Firmware 2.06.3 bug list:

List of bugs/improvement requests

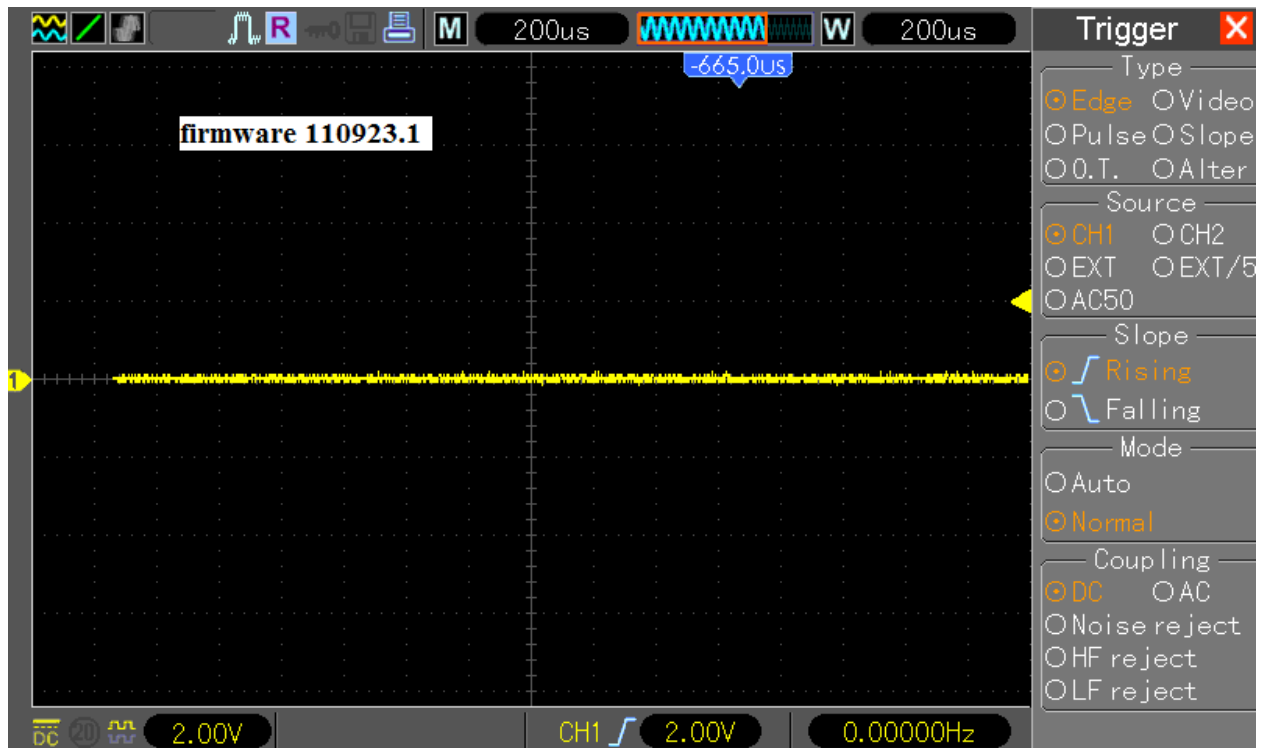
28. Someone told me that there was “problem in csv exported data, no timestamp inside. This seems to be fixed in 2.06.3_121027.0”. Honestly, I see timestamp in scientific format but no idea if this is really fixed; for me it’s a bit strange when multiple data points are on same stamp, e.g. (steps are here in ns valued but then cut in format):

If the smallest step is e.g. 40ns then timestamp for every point should be always in ns and not increasing:

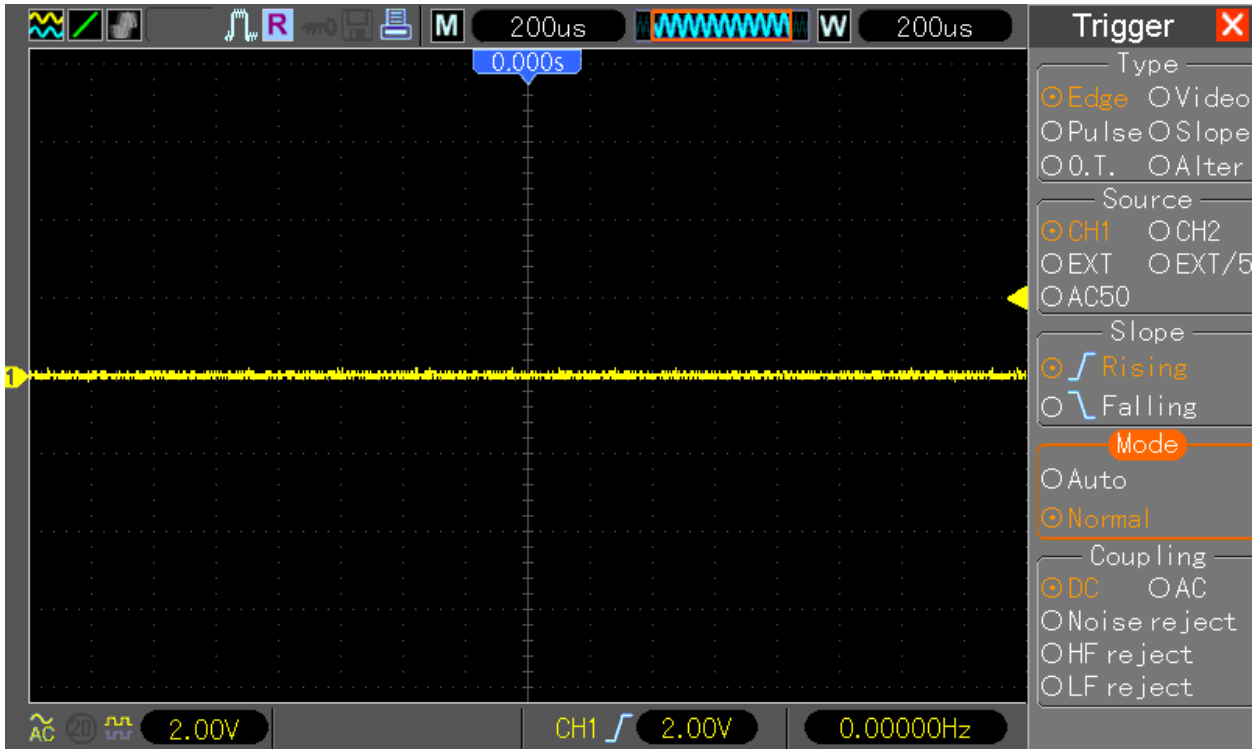
29. Horizontal Position knob not moving display data. Set Trigger to “Normal” – when DSO not triggered the waveform/horizontal screen position cannot be changed. Once triggered it changing rapidly. Another example – set trigger to Single Seq and Auto , while trigger in “R” (ready) mode waveform/horizontal screen position cannot be moved. Again, once triggered it change rapidly. **In firmware 110923.1 this was working! :**

but since few firmware version not anymore working (same condition, Horizontal position knob already turned few times but no move on screen):

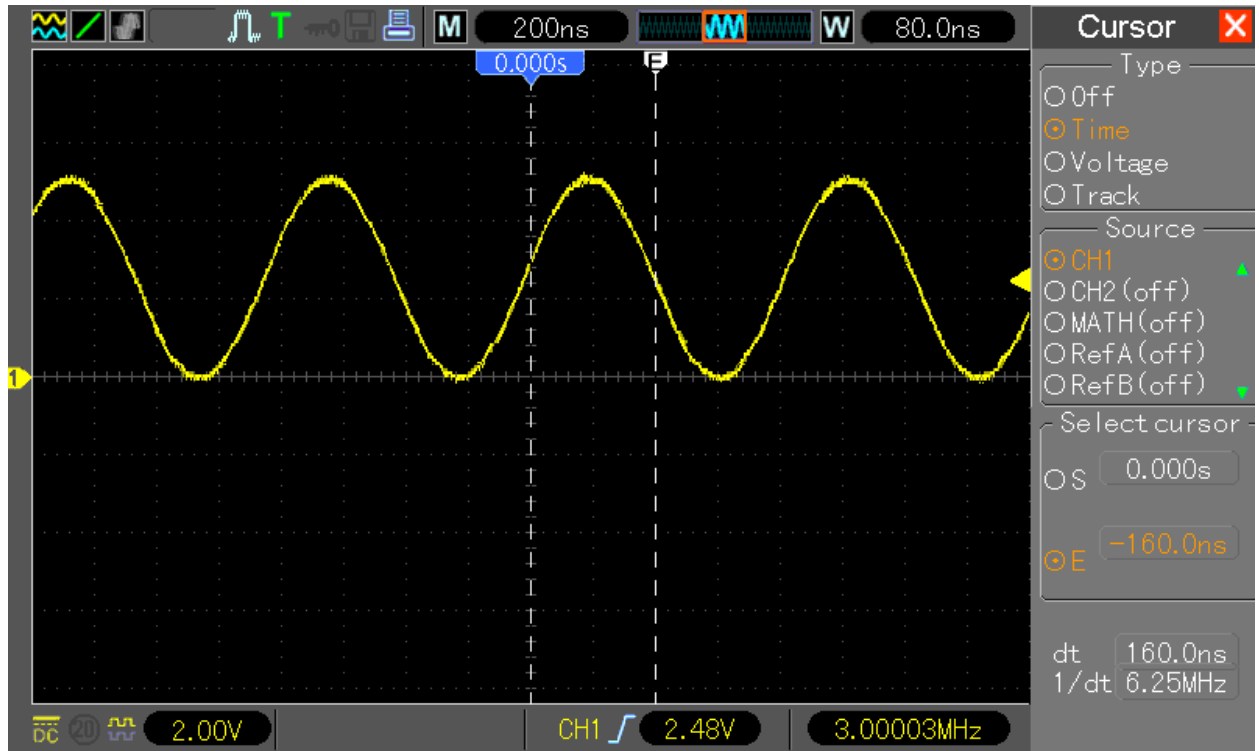
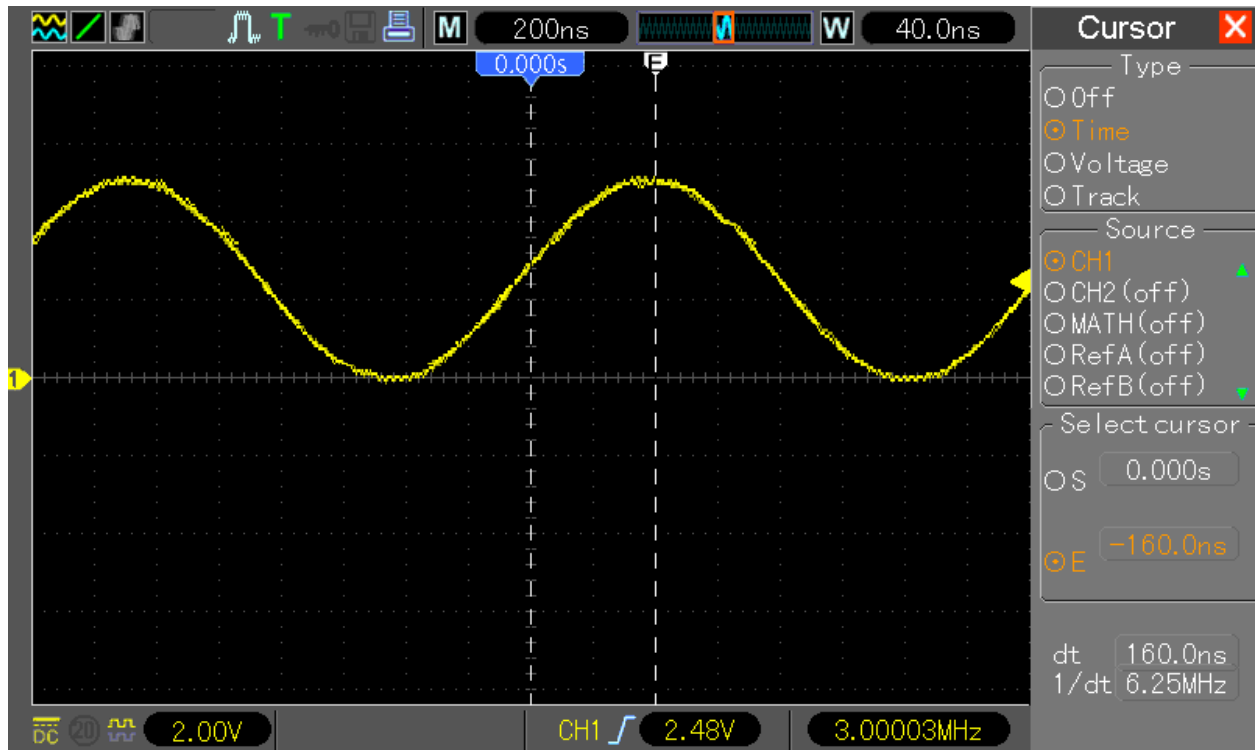
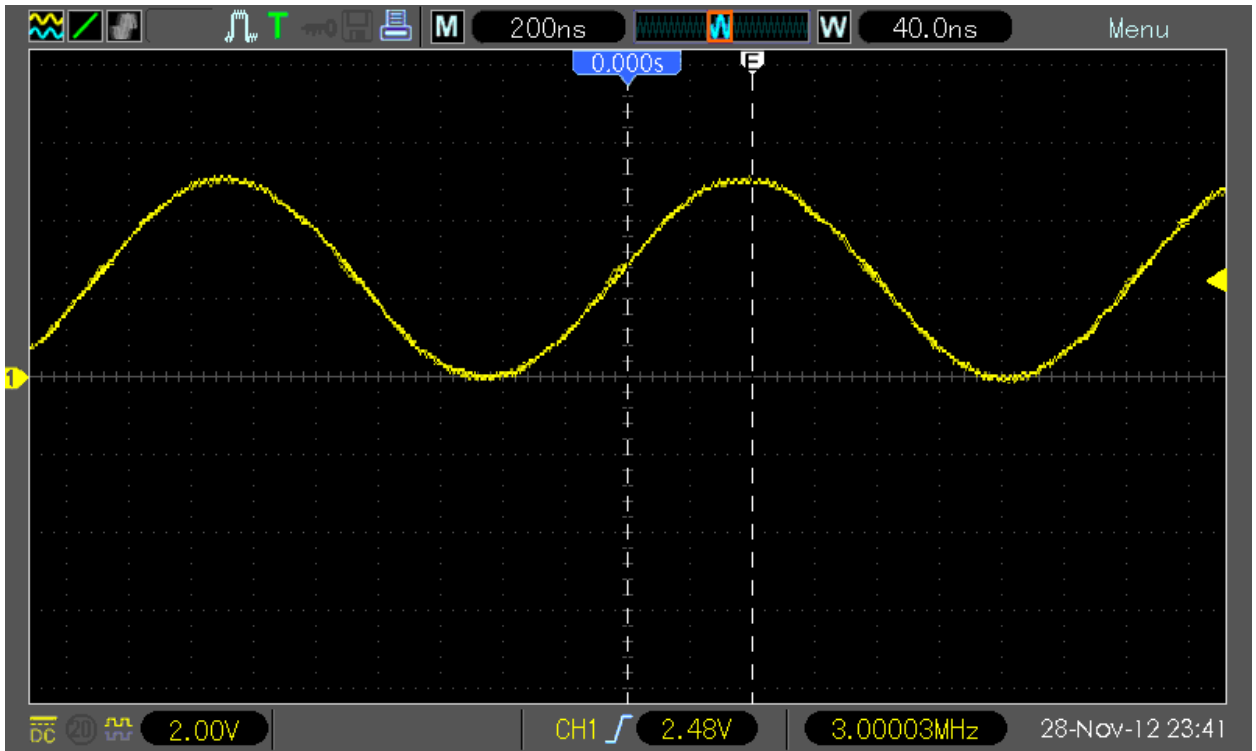
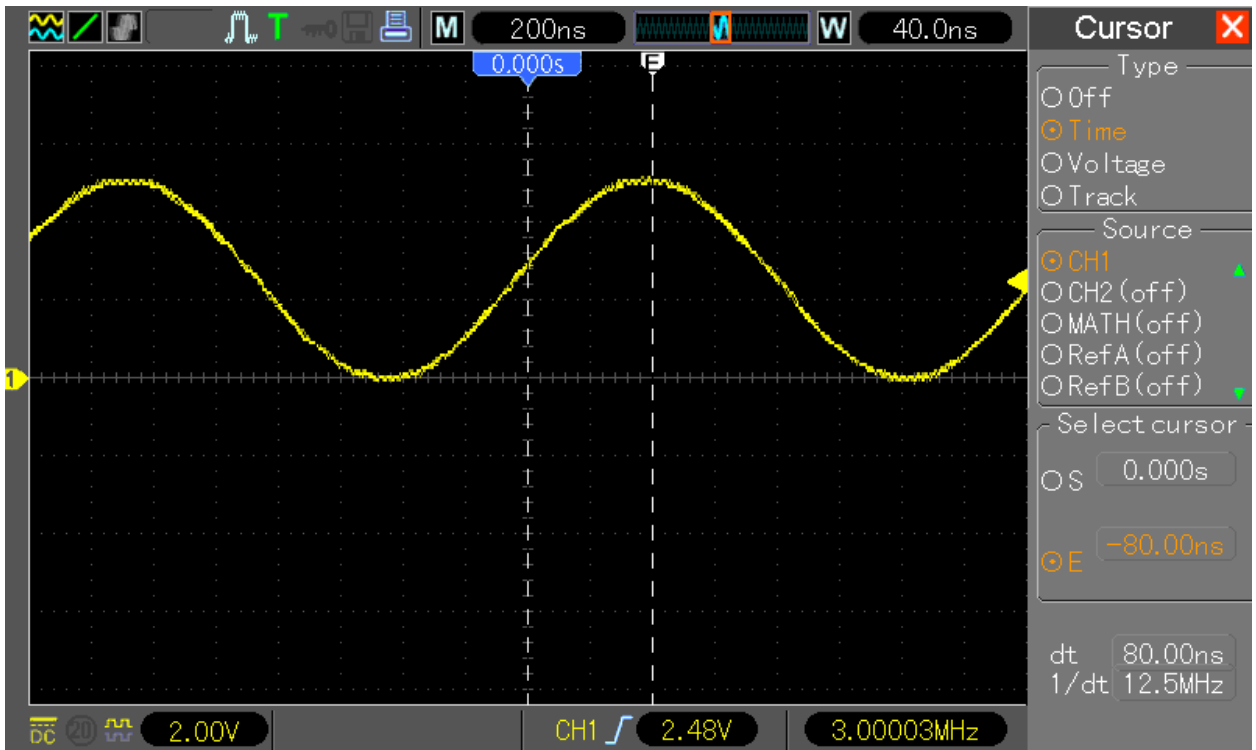
31. In RUN and STOP mode, while changing Timebase the Time Cursor values S and E not refreshing automatically. Any changes to Menu (hide/show with F0), other Knobs (like V0) position or any Buttons (e.g. push Measure button and again Cursor button) is refreshing the S and E values in Menu.

Here example, TB set to 80ns/DIV, cursor S to 0.0ns and E to -160ns:

Then TB changed to 40ns/DIV, but displayed value for E still -160ns:

Now disabling Menu with F0:

and enabling Menu again with F0. The E cursor value is now having proper value (-80ns):

This was working properly the last time in firmware 110923.1
